Product Information

Changeover from RKP to RKP-II

Sizes 63, 80 and 100 cm³/rev

Advantages and characteristics of the new radial piston pump RKP-II compared to the previous RKP design

Figure 1: Noise pressure levels of the RKP-II with load sensing compensator J1 at $n = 1500 \text{ min}^{-1}$ and $Q = Q_{max}$

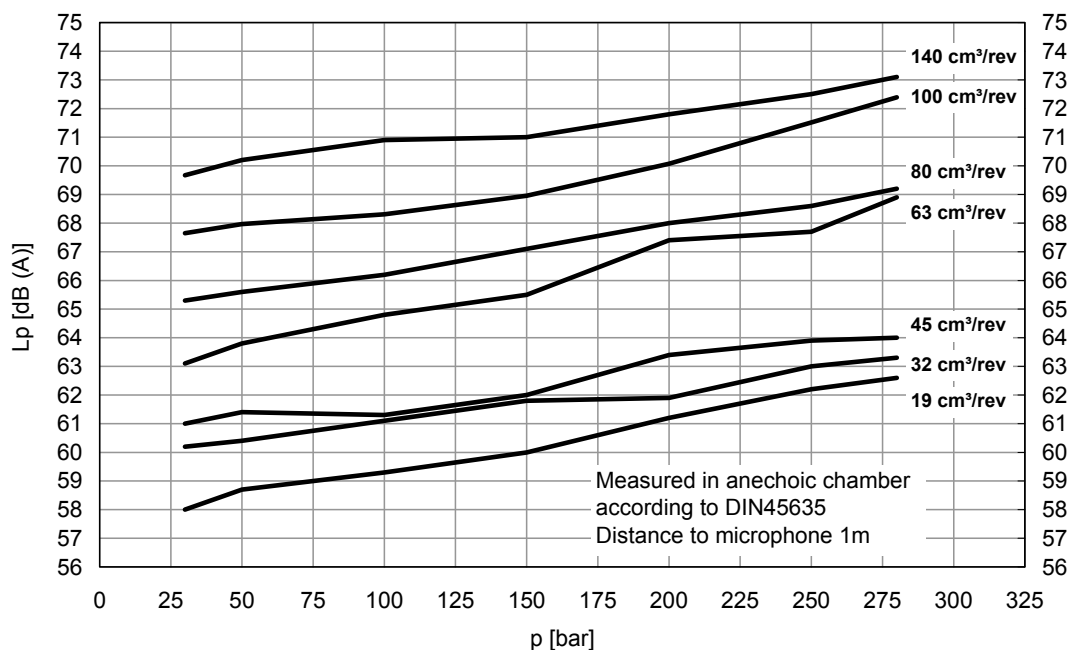
When compared to its predecessors, the acoustic power of the RKP-II has been reduced by 50 to 60 %, depending on the duty point. With this improvement, RKP-II contributes to machine builders efforts to fulfill the EG standards with regards to noise (2003/10/EG). The noise pressure levels of the different sizes are shown in Figure 1.

Figure 2: Comparison of the suction sides of RKP-II and the previous design RKP

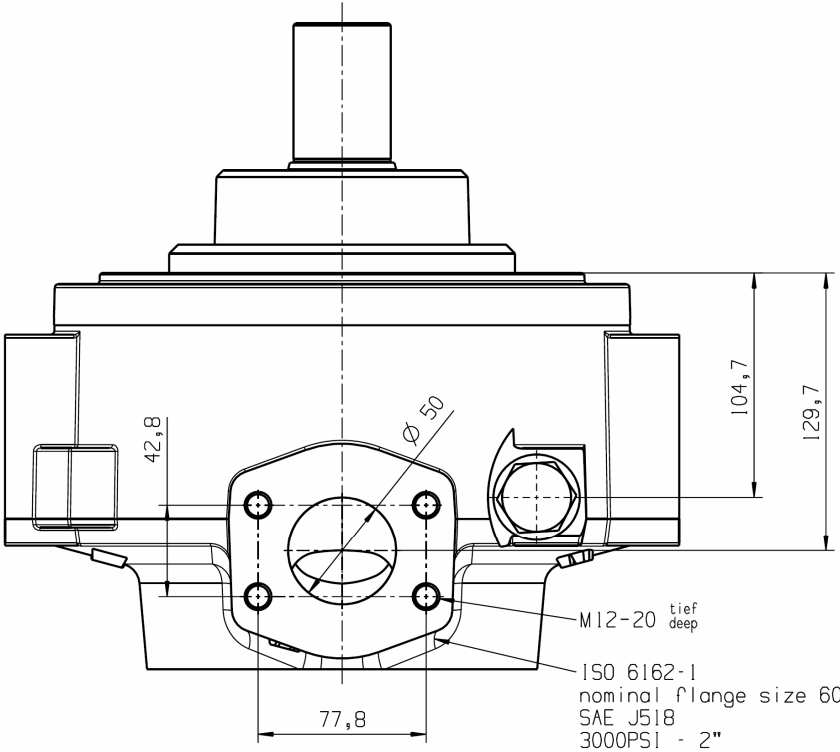
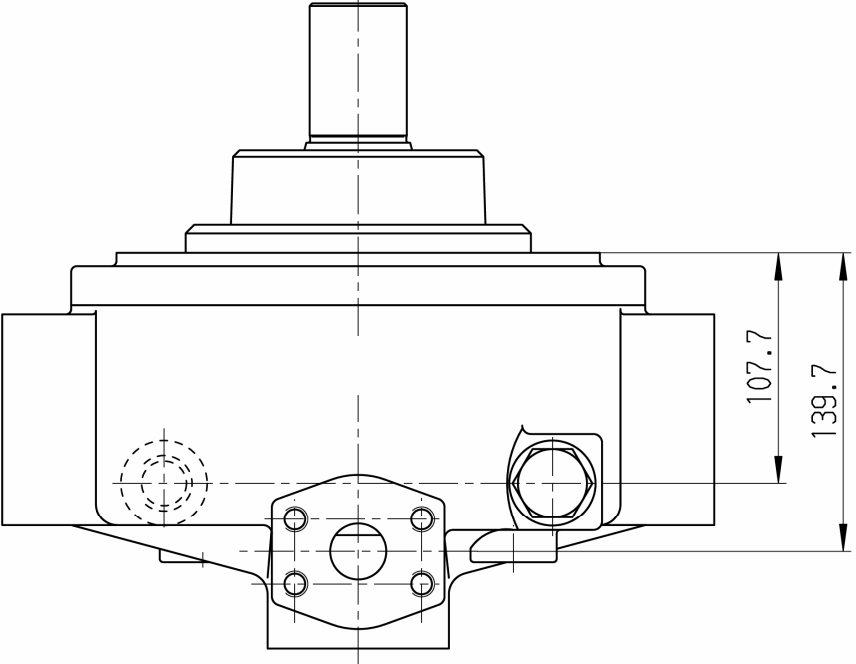
The position of the fluid ports on sizes 63, 80 and 100 cm³/rev has changed by up to 10 mm when compared to the RKP. The drawings shown in Figures 2 to 4 set out the new dimensions when compared to those on the previous RKP. Dimensions which have not changed have been omitted from this representation.

For the sizes 63, 80 and 100 cm³/rev, the suction port was enlarged to SAE 2". This enables the connection of a 2" suction pipe without the requirement for a reducing piece as needed previously. The sizes of the pressure port and the leakage ports remain unchanged.

The suction port is often connected to a solid pipe that has to match in position and size a hole in the tank cover. In this case, a suitable adapter can be used to compensate for the different flange sizes and the offset. The suction pipe must then be shortened by the thickness of the adapter. Information on such adapters are available upon request from Moog.

Figure 3: Comparison of the pressure sides of RKP-II and the previous design RKP

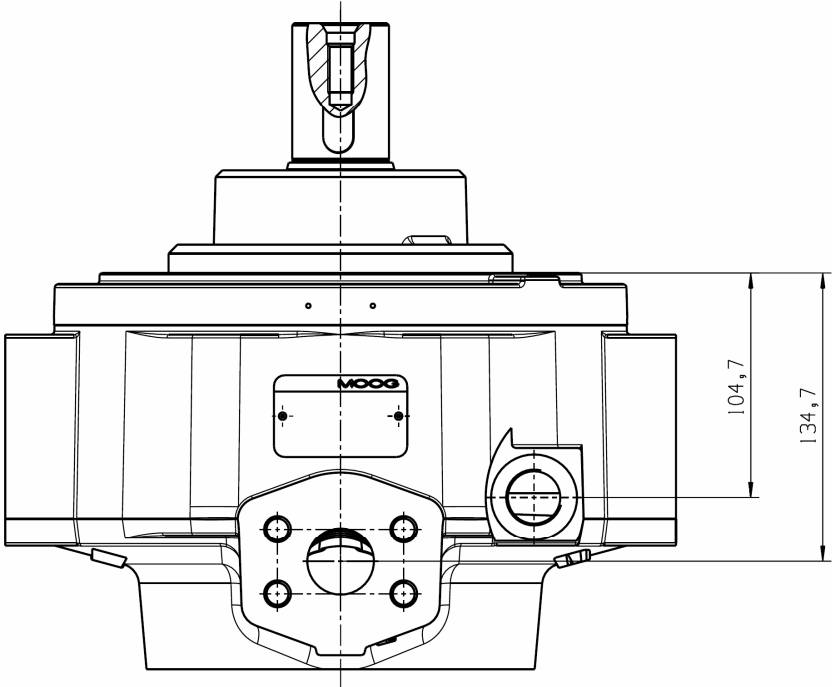
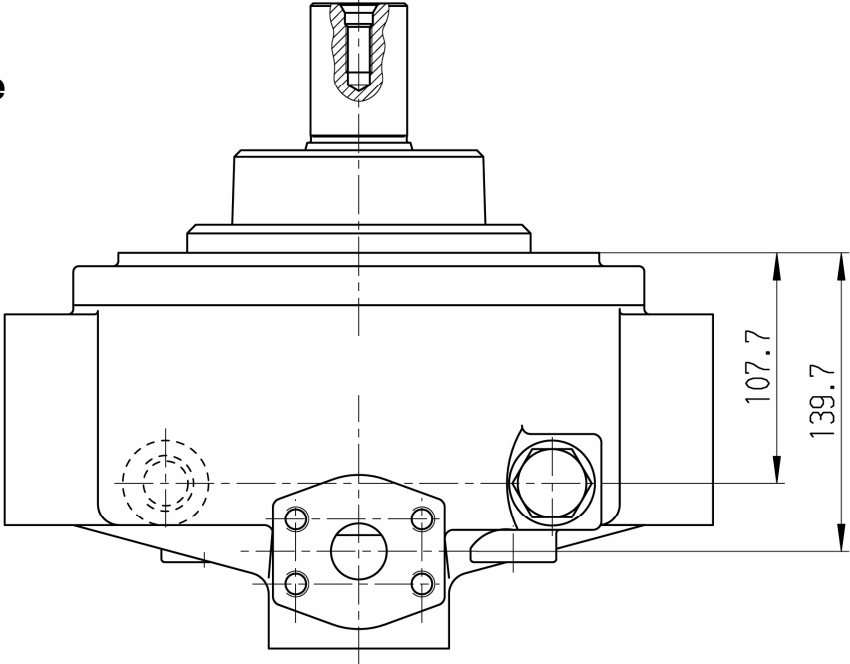
The pressure pipe and the leakage pipes are mostly built as hoses and therefore allow for a certain displacement of the ports. In each particular case, it has to be confirmed that sufficient space is available.

Figure 5: R1-type compensator of the RKP-II, sizes 63, 80 and 100 cm³/rev

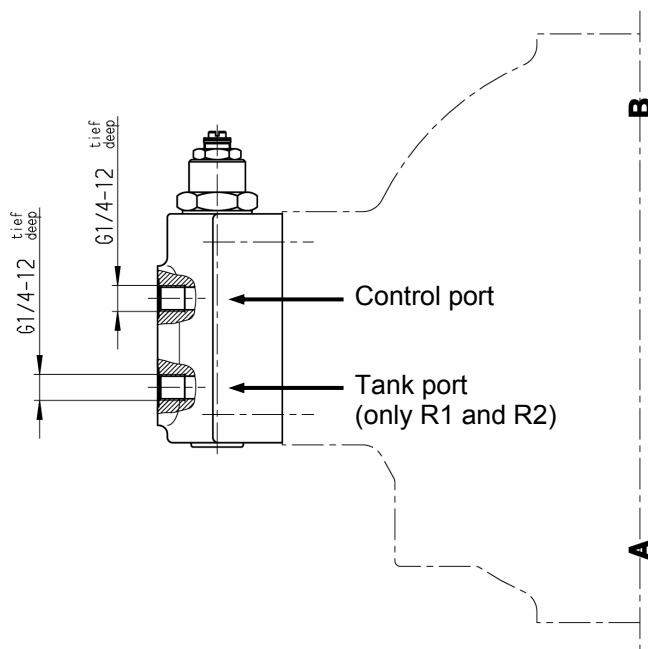
The control port connection has been changed from M 12x1,5 to G 1/4. The tank port connection (only existent in R1 and R2-type compensator) has been changed from M 14x1,5 to G 1/4, too. The position of the ports in the compensator housing remain unchanged. As an example, Figure 5 shows the R1-type compensator with the new port connections.

Fittings with G threads are available for all recommended control hose sizes. An additional adapter fitting is no longer required.
